# Access Compliance Report

## Public Rights-of-Way

### (Curb Ramps)

Intersection ID: 28154	Main Street: AUTUMN_APPLAUSE_DR	Cross Street: WILLOW_TREE_LN	Location: SW
ADA ID: 5825A5A00990	Ramp Type: BlendTrans1	Initial Pass/Fail: Fail	Overall Compliance: No
Codes/Mitigation Info/Possible Solution		Field Measurements/Component Compliance	
Severity Score: 17.5

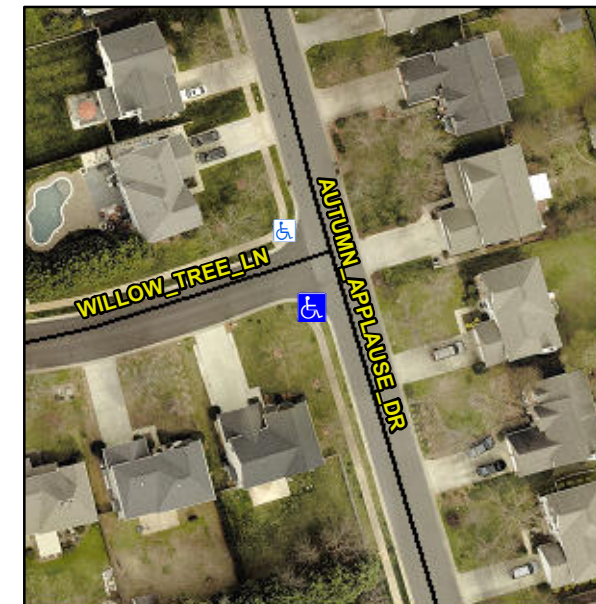
**Not Found, R304.5.1**

Compliance	Description	Data	Compliance	Description	Data
N/A	Ramp Length (in)	98.0	Yes	BlendTrans Slope (%)	4.5
No	Ramp Width (in)	33.0	Yes	BlendTrans XSlope (%)	1.0
N/A	Flare Type LT	N/A	N/A	Flare Type RT	N/A
N/A	Flare Slope LT (%)	N/A	N/A	Flare Slope RT (%)	N/A
N/A	Flare Traversable LT?	N/A	N/A	Flare Traversable RT?	N/A
N/A	Landing Length (in)	N/A	N/A	DWS Provided?	N/A
N/A	Landing Width (in)	N/A	N/A	DWS Contrast?	N/A
N/A	Landing Slope (%)	N/A	N/A	DWS Length (in)	N/A
N/A	Landing X Slope (%)	N/A	N/A	DWS Full Width?	N/A
N/A	Landing Curb? (Y/N)	N/A	N/A	DWS Offset (in)	N/A
N/A	Shared Landing?	N/A			
N/A	Gutter Ponding?	N/A	N/A	Gutter Slope (%)	N/A
N/A	Gutter Lip Ht (in)	N/A	N/A	Gutter X Slope (%)	N/A
N/A	Painted X Walk1?	No	N/A	Painted X Walk2?	No
	X Walk 1 Direction	To NE		X Walk 2 Direction	To NW
	X Walk 1 Width (in)	N/A		X Walk 2 Width (in)	N/A
	X Walk 1 Slope (%)	3.2		X Walk 2 Slope (%)	1.4
	X Walk 1 X Slope (%)	1.5		X Walk 2 X Slope (%)	2.9

N/A	Ramp inside XWalk1?	N/A	N/A	Ramp inside XWalk2?	N/A
	Road Slope (%)	0.2		Clear Space?	N/A
	Road X Slope (%)	7.7	N/A	Clear Space to XWalk (in)	N/A
N/A	Any Obstructions?	N/A	N/A	Storm Grate/Utility Hazard?	N/A
	Obstruction Type			Storm Grate/Utility Type	
		N/A			N/A
			Yes	Surface Condition? (G/P)	Good
			No	Curb Slope (%)	19.9

**Remove & Replace Curb Ramp With Two New Directional Ramps or Equivalent.**
